HISTORIC PRESERVATION BOARD STAFF REPORT

46 Marine Way

Meeting	File No.	Application Type
June 3, 2026	HP-544-2026	Certificate of Appropriateness, Demolition, Relocation, Variances, & Waivers

SITE PLAN
 1" = 10'-0"

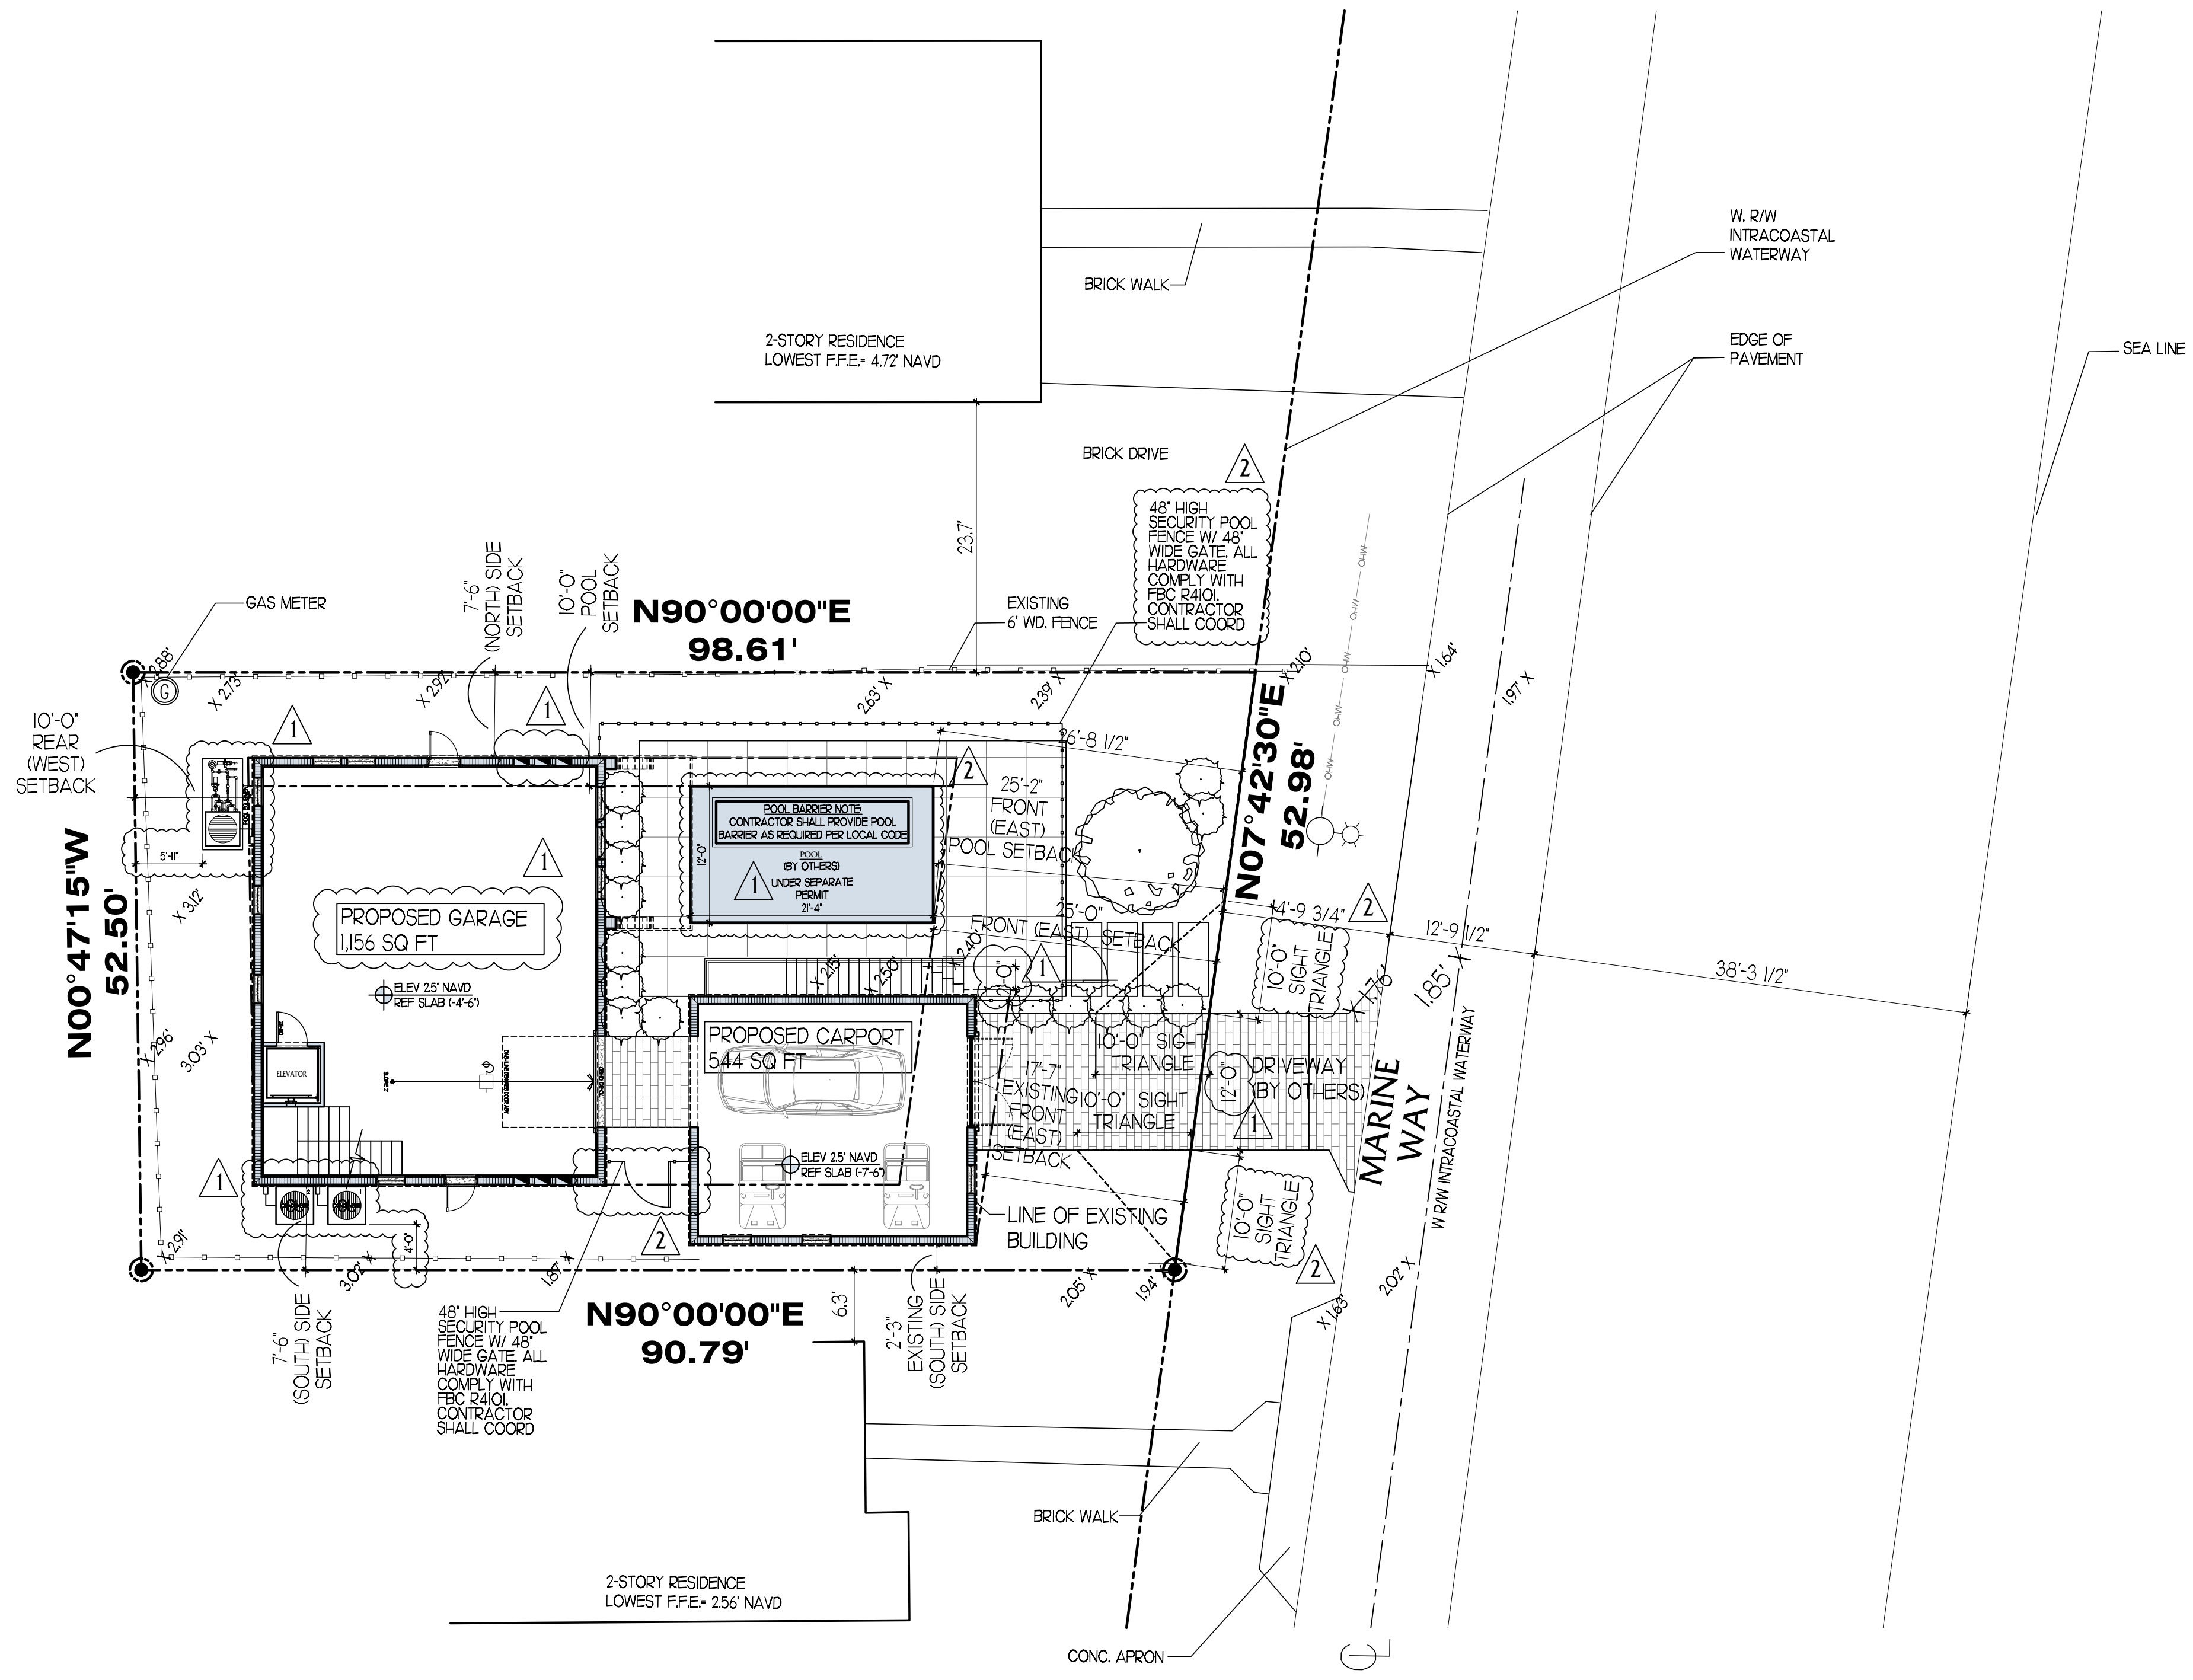
1. That the site data table be revised prior to site plan certification to indicate open space calculations that are based on open space percentage requirements, not the impervious/pervious values;

4. That any proposed fencing within the front setback not be taller than 4 feet and no taller than 3 feet within any sight visibility triangles;
5. That sight visibility triangles that are in compliance with LDR Section 4.6.14 are illustrated on the site plan prior to site plan certification;
